SUBJECT: WATTS BAR NUCLEAR PLANT, UNIT 1 - ISSUANCE OF AMENDMENT TO
TECHNICAL SPECIFICATION 4.3.1 CRITICALITY (TAC NO. MF2515)

Amendment No. 95
License No. NPF-90

SAFETY EVALUATION BY THE OFFICE OF NUCLEAR REACTOR REGULATION
RELATED TO AMENDMENT NO. 95 TO FACILITY OPERATING LICENSE NO. NPF-90

FIGURE 4.3-3
MINIMUM REQUIRED BURNUP FOR UNRESTRICTED STORAGE
OF FUEL OF VARIOUS INITIAL ENRICHMENTS

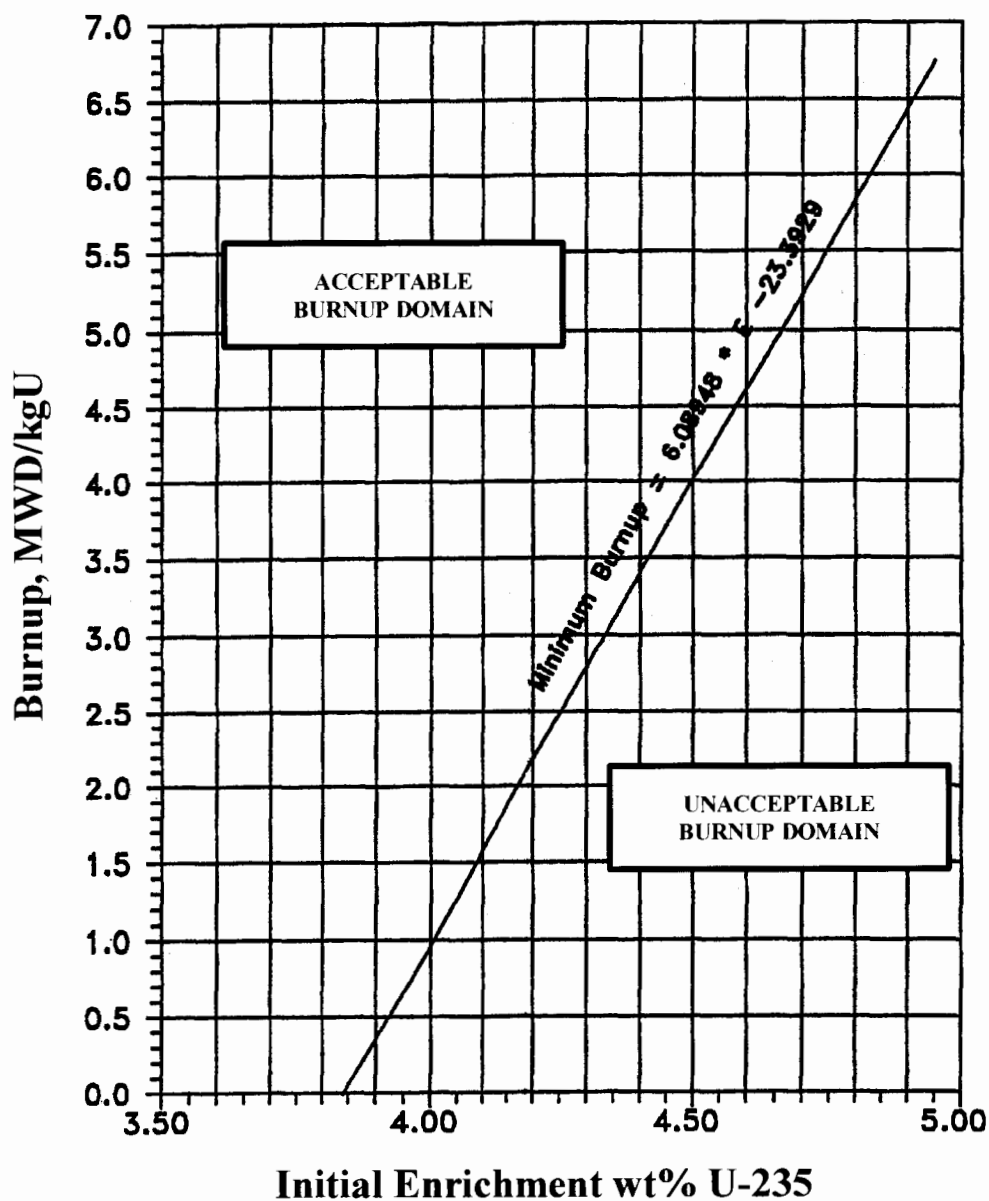
1. Fuel assemblies may be stored in the racks in an all cell arrangement provided the burnup of each assembly is in the acceptable domain identified in Figure 4.3-3, depending upon the specified initial enrichment.

TVA proposes to revise WBN Unit 1 TS to remove the allowance of fuel assemblies with enrichments less than or equal to 3.80 weight percent U-235 be stored without restriction. Currently, all acceptable and unacceptable storage regions in terms of burnup versus initial U-235 enrichment conditions are defined by burnup curve figures in the TS Figure 4.3-3 for non-checkerboard configurations and Figure 4.3-4 for checkerboard configurations. Figure 4.3-3 includes a zero burnup storage limit at approximately 3.84 weight percent U-235. In the proposed revised TS, the existing TS 4.3.1.1.d would be deleted, and TS 4.3.1.1.e would be renumbered and revised to clarify that meeting "any" one of the four described storage arrangements satisfies the TS requirement for new and spent fuel. The NRC staff determined that the removal of previous TS 4.3.1.1.d as proposed would resolve the inconsistency between the allowance for unrestricted storage provided in TS 4.3.1.1.d and the restrictive arrangement described in TS 4.3.1.1.e.2, which includes TS Figure 4.3-4 for storage of new and spent fuel assemblies in the spent fuel racks. The proposed change would also modify current TS 4.3.1.1.e.1 and the title of TS Figure 4.3-3 to clarify that both are applicable to all fuel assemblies and not only spent fuel assemblies. These changes are consistent with the existing criticality safety analysis and the burnup curve in Figure 4.3-3, which has a zero burnup value applicable to new fuel.

Based on the above evaluation, the NRC staff has concluded that the proposed TS changes to remove the inconsistencies and clarify existing requirements in TS 4.3.1.1 and Figures 4.3-3 and 4.3-4, are editorial in nature, thus, the proposed changes are acceptable.

FIGURE 4.3-4
MINIMUM REQUIRED BURNUP FOR A CHECKERBOARD ARRANGEMENT OF 2 SPENT AND 2
NEW FUEL ASSEMBLIES OF 5wt% U-235 ENRICHMENT (MAXIMUM)

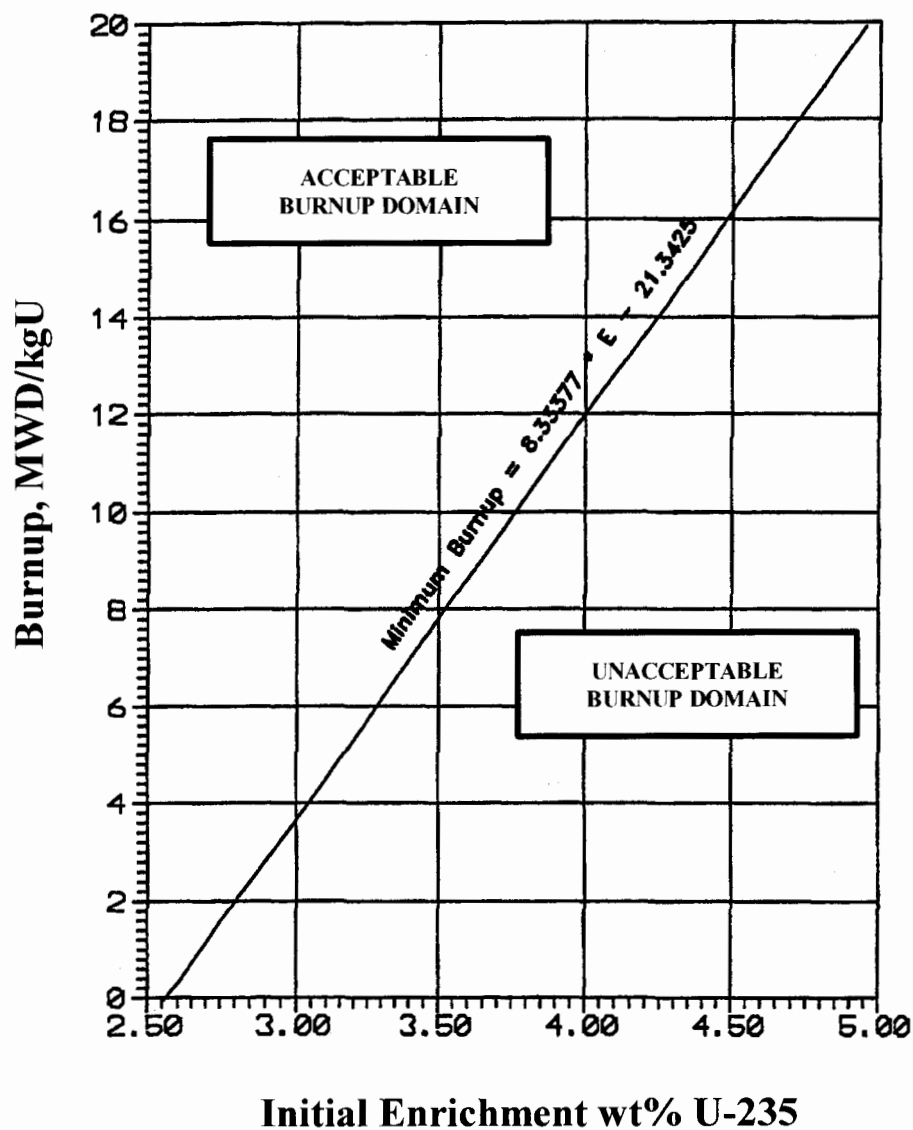
2. New and spent fuel assemblies may be stored in a checkerboard arrangement of 2 new and 2 spent assemblies, provided that each spent fuel assembly has accumulated a minimum burnup in the acceptable domain identified in Figure 4.3-4.

The title of Figure 4.3-4 is also revised to indicate it applies to assemblies stored in a checkerboard arrangement of two spent and two new fuel assemblies to be consistent with the language in current TS 4.3.1.1.e.2. Also, the weight percent abbreviation (wt%) and U-235 are added in the title for clarification purposes.
